Loudoun County, Virginia

## NOTICE TO BIDDERS

### ADDENDUM NO. 2

The following changes and/or additions shall be made to the original Invitation for Bid (IFB) No. RFQ 80781, IDentiCard PremiSys Installation and Maintenance Services.

## **ATTACHMENT 4A – SAMPLE TASK 1**

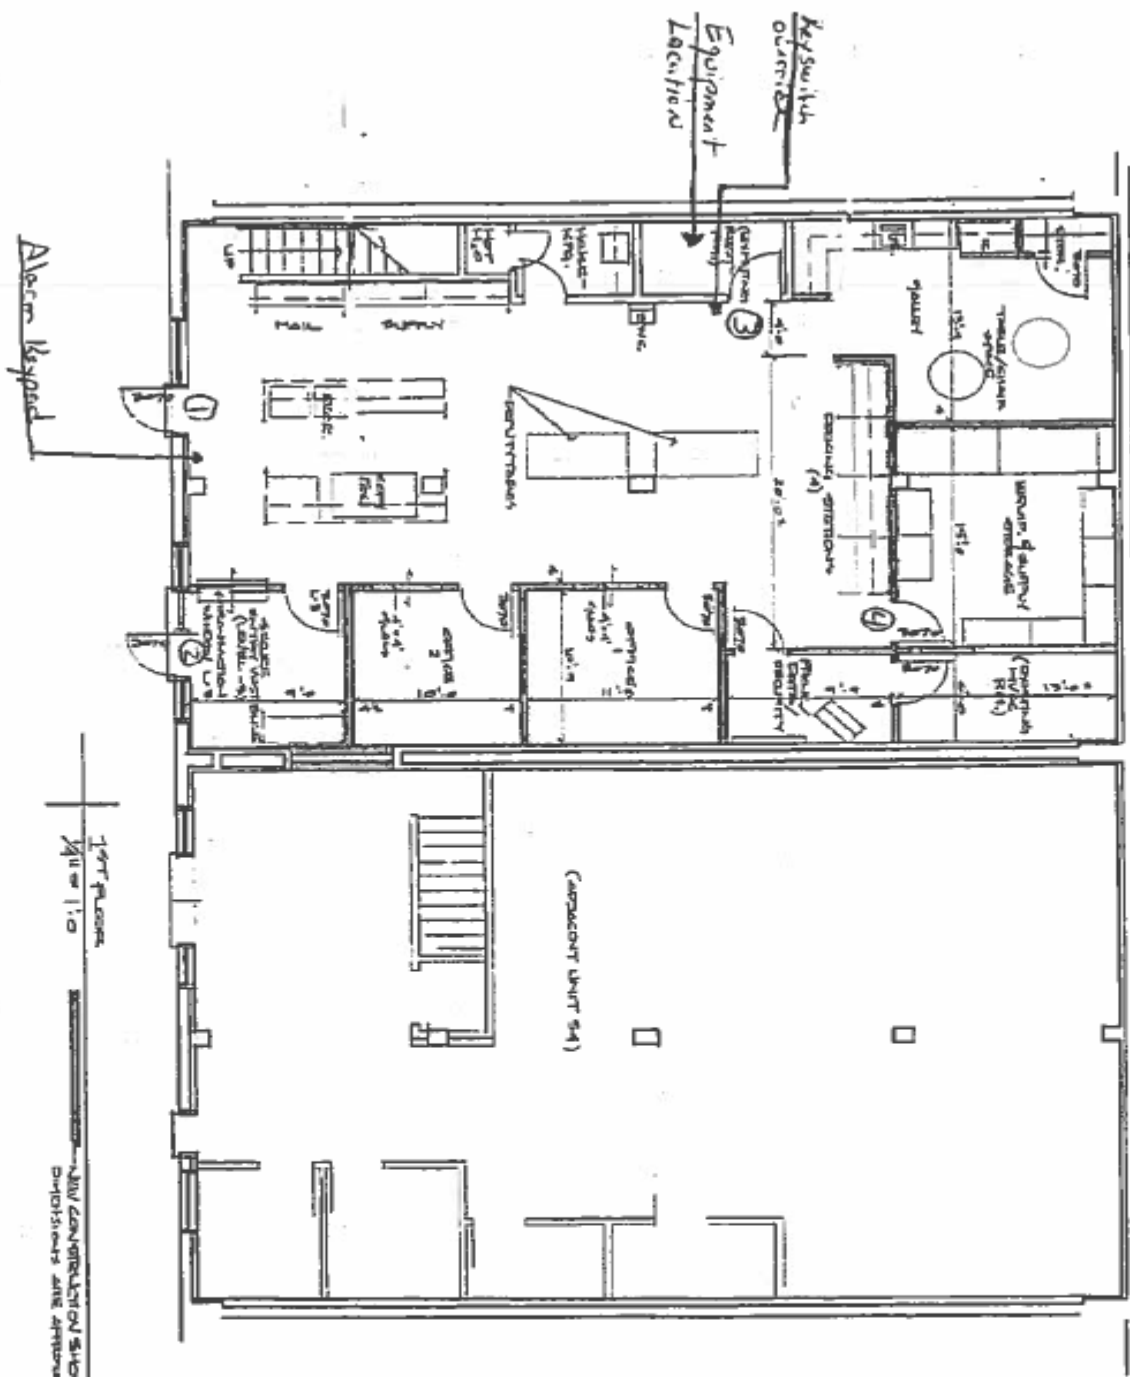
**Q6. What is the required Battery Back-Up Time?**

**Q7. Attachment 4A – Sample Task 1 – Please clarify paragraph 3 and how the DMP and PremiSys systems are to work in tandem?**

A6. 8 Hours Minimum

A7. The DMP alarm zones will be connected to the PremiSys system so the door contacts can be shunted by time zones through the PremiSys system to control alarming of the doors
